Interactive comment on “Two independent methods for mapping the grounding line of an outlet glacier – example from the Astrolabe Glacier, Terre Adélie, Antarctica” by E. Le Meur et al.

Anonymous Referee #2

Received and published: 2 January 2014

Fig. 1.

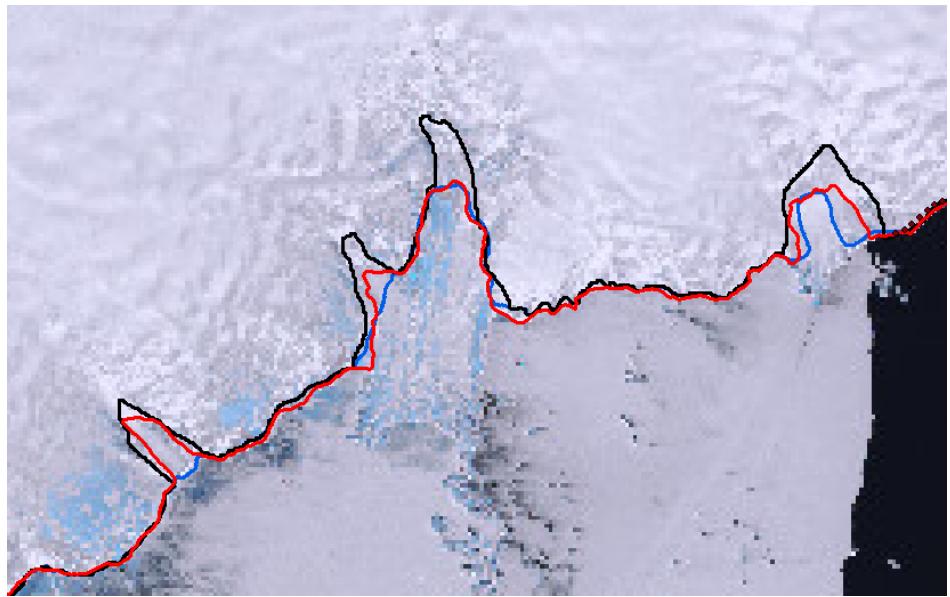
The MOA-based grounding line for Astrolabe Glacier has been significantly revised since the publication of 2007, using a second MOA mosaic assembled in 2010. This is available from NSIDC. See attached. The new line is similar to the Bindschadler et al 2011 ASAID line.
